NATIONAL DAM SAFETY PROGRAM. MINK CREEK DAM (ID NUMBER VA-00352--ETC(U)

Name Of Dam: Mink Creek

PHASE I INSPECTION REPORT

PREPARED FOR
NORFOLK DISTRICT CORPS OF ENGINEERS
803 FRONT STREET
NORFOLK, VIRGINIA 23510

PHOTO 3. Impact Basin Showing Baffle Wall, End Sill and Riprapped Exit Channel

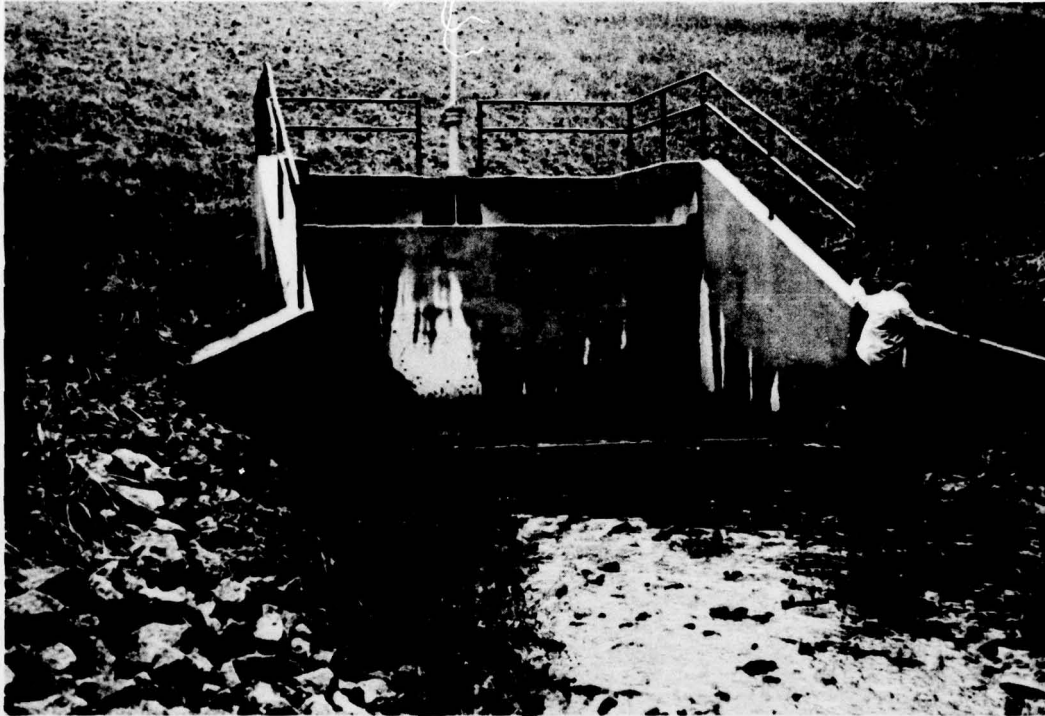
- 3.1.3 Appurtenant Structures: The concrete structures including the riser (see Photo 2) and impact basin (see Photos 3 and 4) are intact without damage. The only deficiency observed was some minor settlement and erosion of the earth backfill near the ends of the concrete walls for the impact basin.

- 3.2.4 Appurtenant Structures: The settlement and erosion of the backfill adjacent to the walls of the impact basin should be repaired with compacted soil and the area should be reseeded. Surface runoff should also be diverted.

PHOTO 4. Impact Basin, Downstream Channel, End of Emergency Spillway, (At right) and Homes in Downstream Area

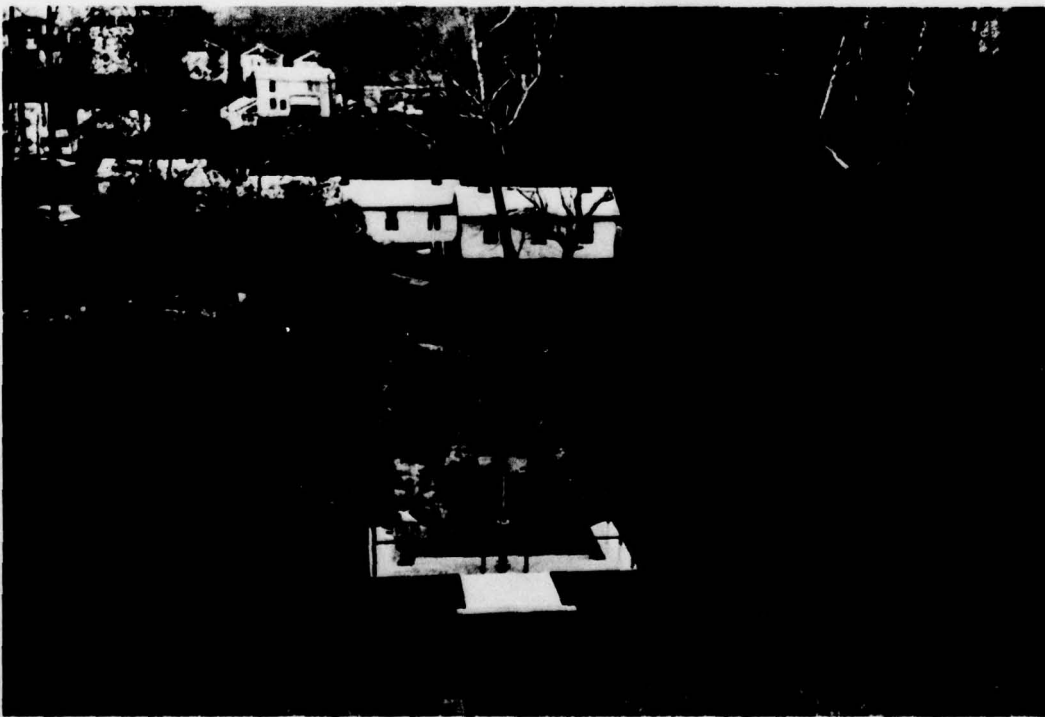
- 3.1.5 Reservoir Area: The reservoir area did not have any significant shoreline erosion.
- 3.1.6 Downstream Channel: The downstream channel (see Photo 4) is unobstructed and well formed with stone riprap adjacent to the impact basin, bedrock bottom and soil slopes further downstream.

5.8 Evaluation: Mink Creek Dam, classified as a "small" size-"high" hazard dam, is required to pass a spillway design flood of a size between 1/2 PMF and PMF according to the Recommended Guidelines for Safety Inspection of Dams. Where there is a given range for the spillway design flood, the magnitude that most closely relates to the involved risk was selected. Due to the proximity of the homes located immediately downstream from the dam (see Photo 4), the spillway design flood is equal to the PMF.
